# HISTORIC AND DESIGN REVIEW COMMISSION

**HDRC CASE NO:** 2017-459  
**ADDRESS:** 814 BURNET ST  
**LEGAL DESCRIPTION:** NCB 549 (814 BURNET SUB'D {IDZ}), BLOCK 9 LOT 18  
**ZONING:** IDZ, H  
**CITY COUNCIL DIST.:** 2  
**DISTRICT:** Dignowity Hill Historic District  
**APPLICANT:** Felix Ziga/Ziga Architecture  
**OWNER:** Poma Properties, LLC  
**TYPE OF WORK:** Construction of four, two story, single family residential structures  
**REQUEST:**

The applicant is requesting conceptual approval to construct four, two story residential structures on the vacant lot at 814 Burnet.

Gaspar Rivera  
Poma Properties, LLC  
schematic design: proposed site / roof plan  
1/16" = 1'-0"  
9.01.2017

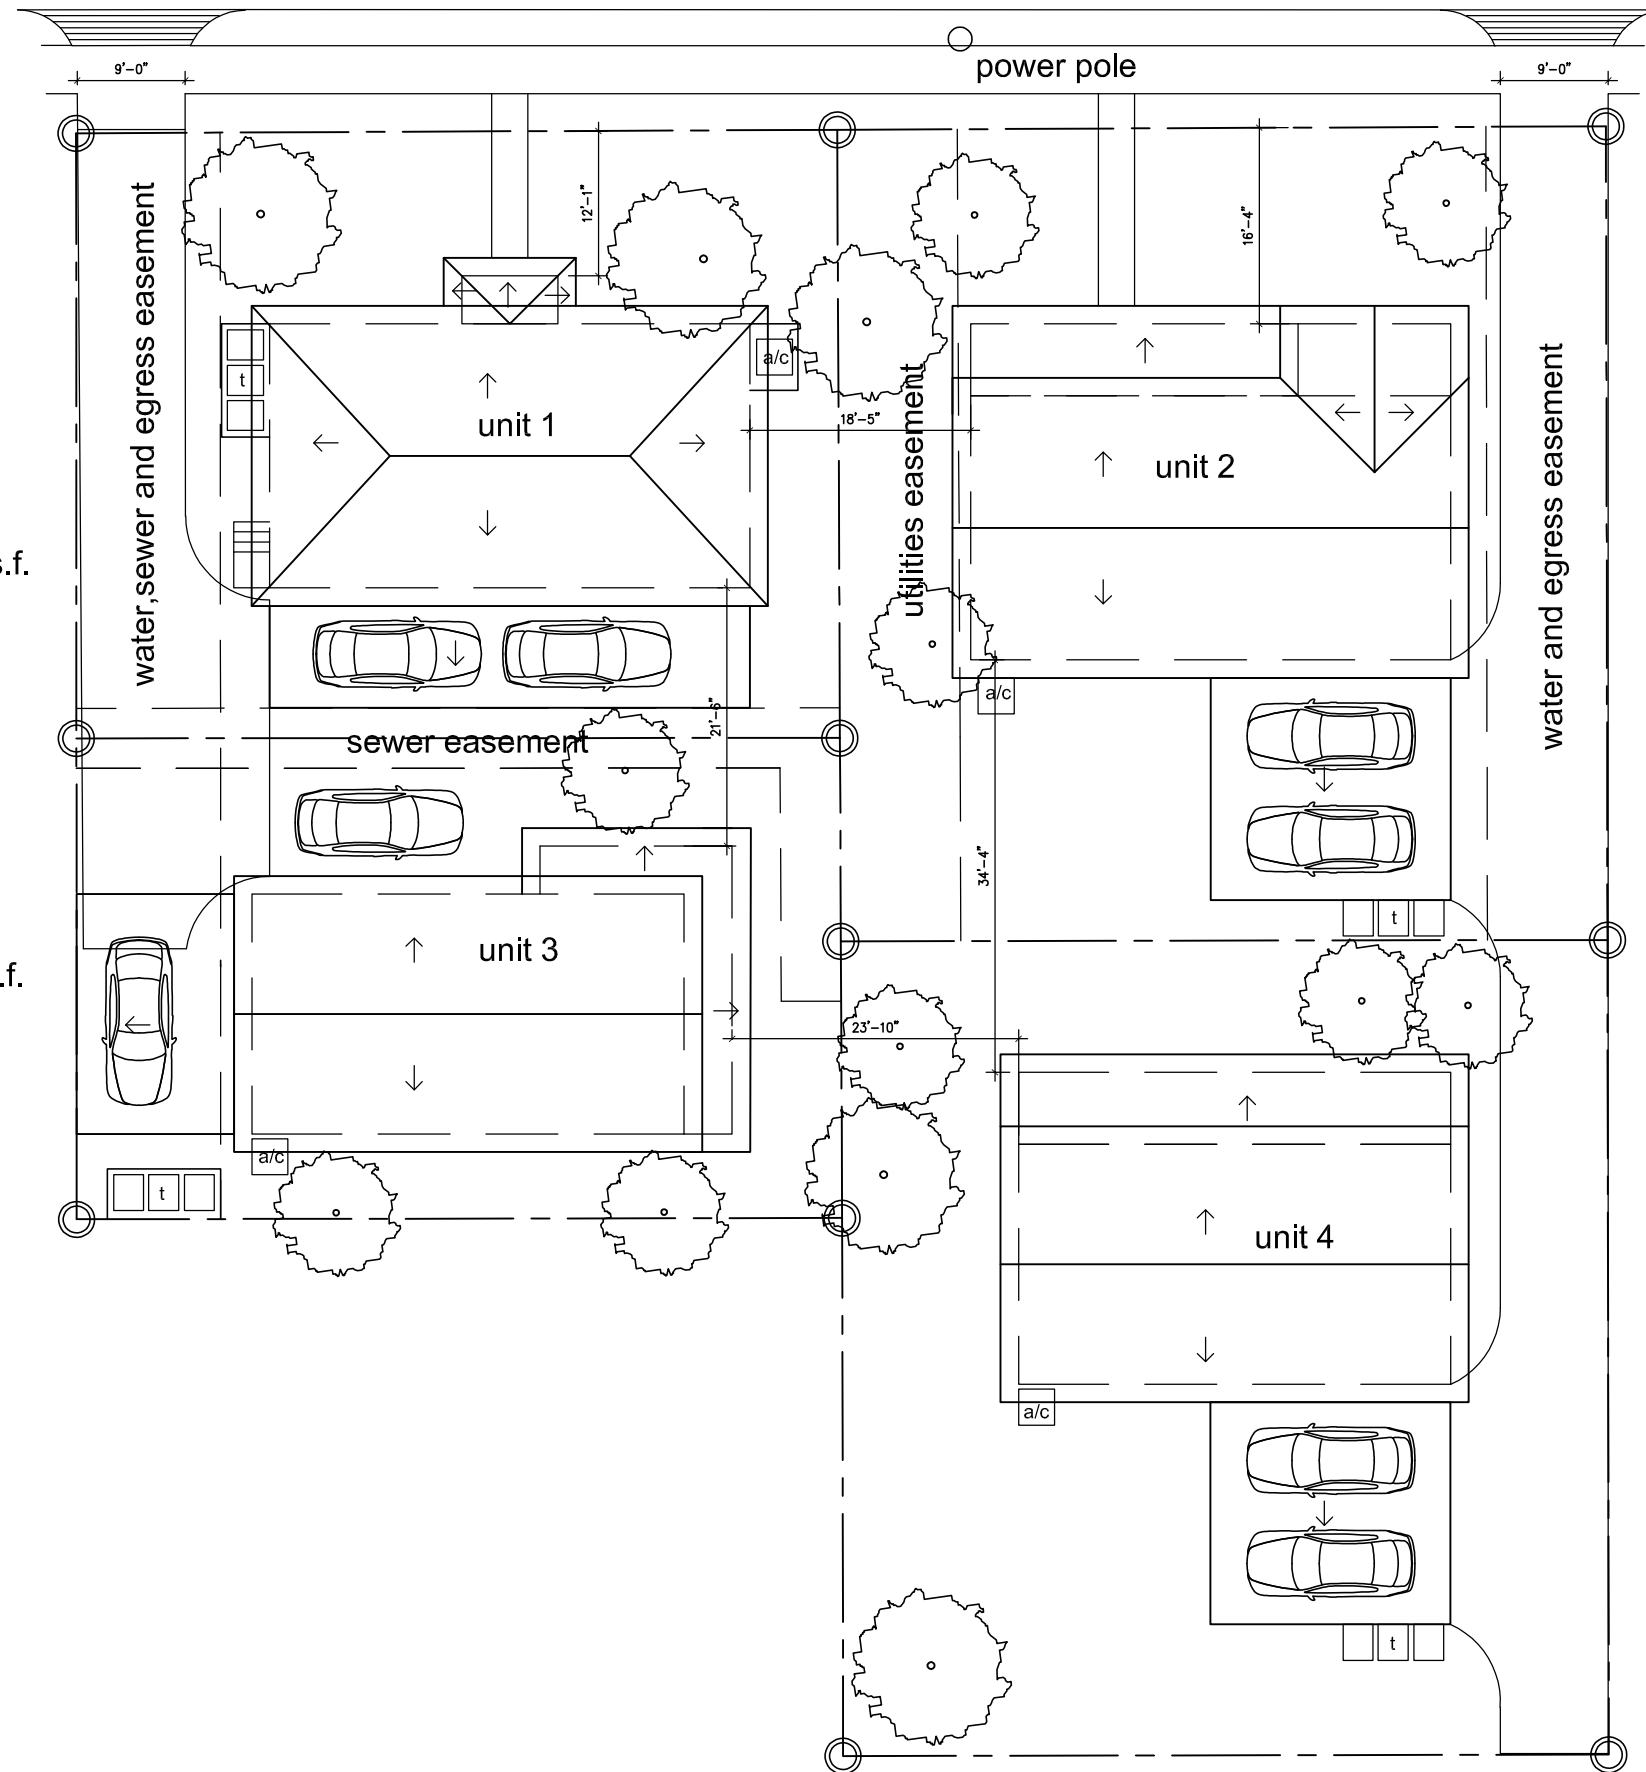
- d. LOT COVERAGE – Many lots in the Dignowity Hill Historic District feature a primary residential structure that fronts a primary street with one or more accessory structures toward the rear of the site. The applicant has proposed to locate two of the two story units on the lots at the rear of the lots adjacent to Burnet Street with a composition similar to that of a primary historic structure with a rear accessory structure.

- r. SIDEWALK – The applicant has noted the installation of a front yard sidewalk for units 1 and 2; however, has not included these on the site plan. The proposed sidewalks should relate to those found historically in the district in terms of location, width and material and should be centered on the front porch of units 1 and 2.

- s. DRIVEWAY – On both the east and west sides of the lots, the applicant has proposed to install driveways to feature nine (9) feet in width. The Guidelines for Site Elements note that driveways should relate to historic driveways in the district and should not exceed (10) feet in width. The proposed driveways are consistent with the Guidelines. Staff finds the installation of two separate driveways located consistently with the pattern within the district is appropriate.

- u. LANDSCAPING – The applicant has noted the location of trees and driveways on the site plan; however, a detailed landscaping plan should be submitted to staff prior to submitting for final approval.

schematic design: street elevations

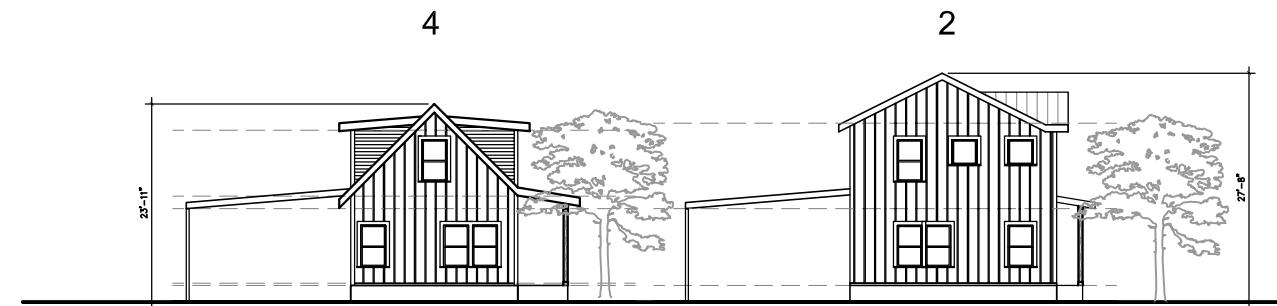
- g. SCALE & MASS – Per the Guidelines for New Construction 2.A.i., a height and massing similar to historic structures in the vicinity of the proposed new construction should be used. In residential districts, the height and scale of new construction should not exceed that of the majority of historic buildings by more than one-story. These two lots are located across Burnet from a two story historic structure and to the immediate west of a two story historic structure. Staff finds heights of two stories for units 1 and 2, that address Burnet is appropriate. At the rear of units 1 and 2, the applicant has proposed units three and four, which are also to feature two stories, but feature an overall height and mass that is subordinate to those of units 1 and 2. Staff finds this modified massing to be more appropriate than the previous proposal of four structures that each shared equal massing.

schematic design: proposed elevations - unit 1

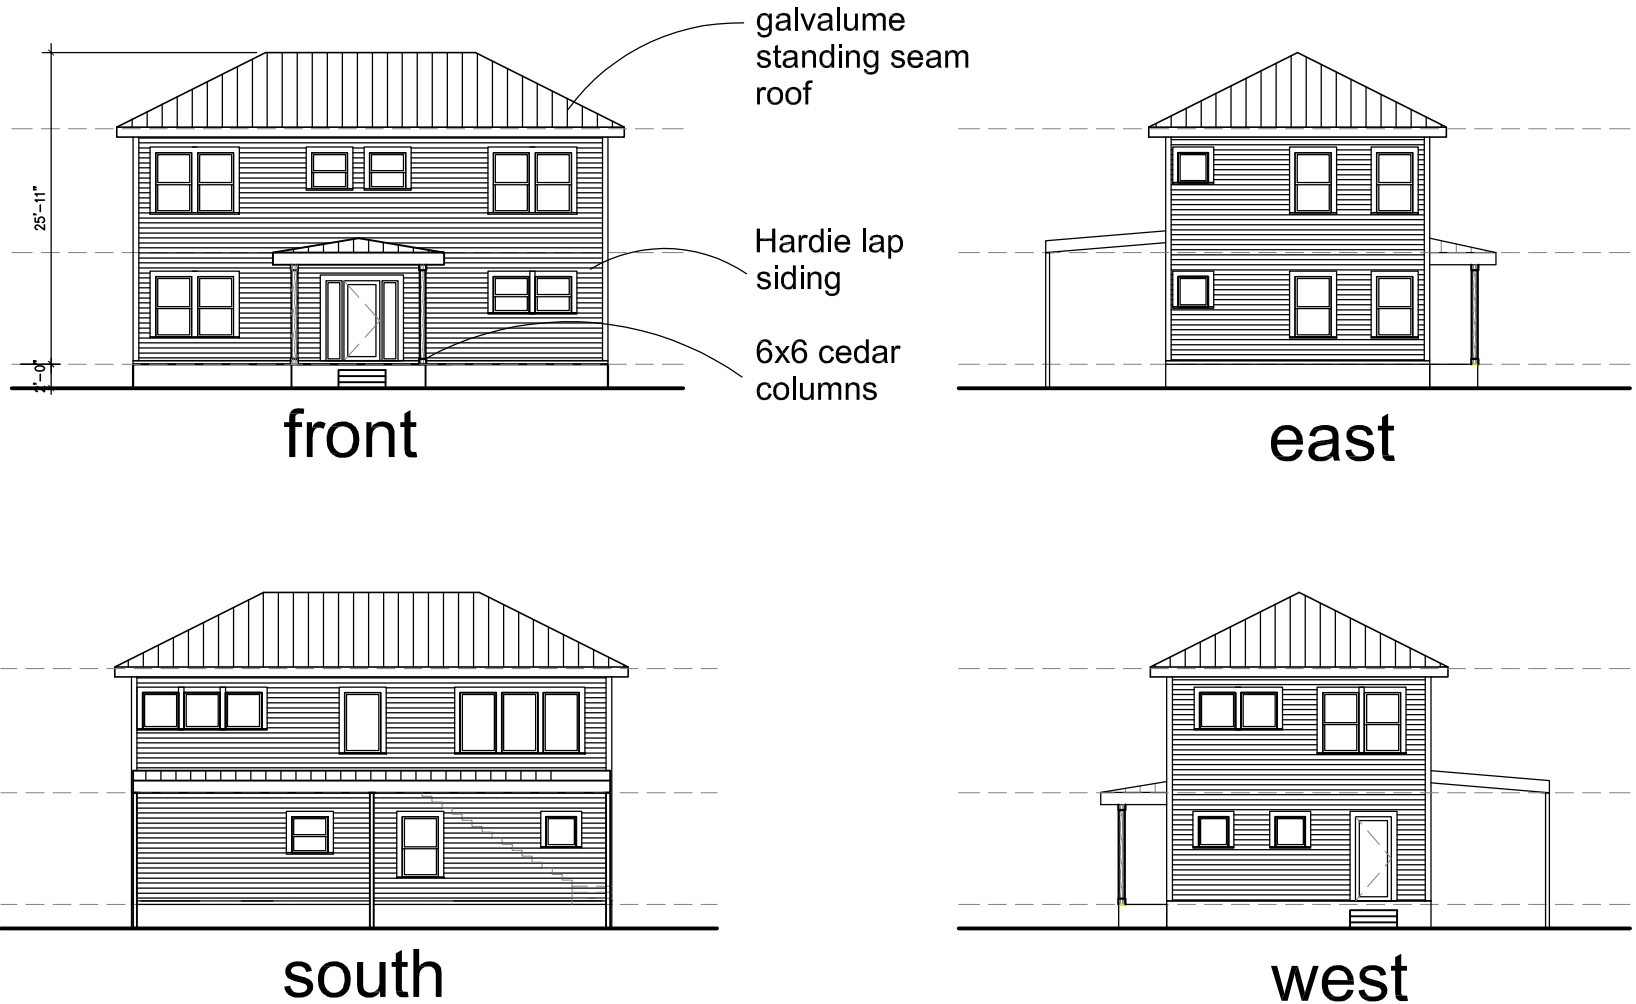
- h. SCALE & MASS – The applicant has noted overall widths of thirty-six and forty feet. The average width for historic structures in the immediate vicinity is between thirty and thirty-five feet. Staff finds the proposed width to be inappropriate and finds that widths should be reduced to become consistent with the nearby historic examples. Additionally, the proposed development pattern has no historic precedent. More variation in building orientation and massing among structures would be appropriate. Additionally, staff finds that a reduction in width of the proposed structures will both improve the proposed massing and architectural proportions.

- j. ROOF FORM – The applicant has proposed for unit 1 to feature a hipped roof, unit 2 to feature a front and side gabled roof, unit 3 to feature a side gabled roof with front facing shed roofs and unit 4 to feature a roof form that matches that of unit 3. Gabled and hipped roofs are found throughout the Dignowity Hill Historic District. Staff finds the scale and massing of the proposed gabled roof for unit 1 to be of a scale that is not found historically in the district. Generally, staff finds the proposed roof form in unit 2 to be appropriate. Staff finds that the proposed roof form found in units 3 and 4 should be modified to include shed that is lesser in mass than currently proposed. Staff finds that the proposed shed roof should feature a steeper pitch and window dormers.
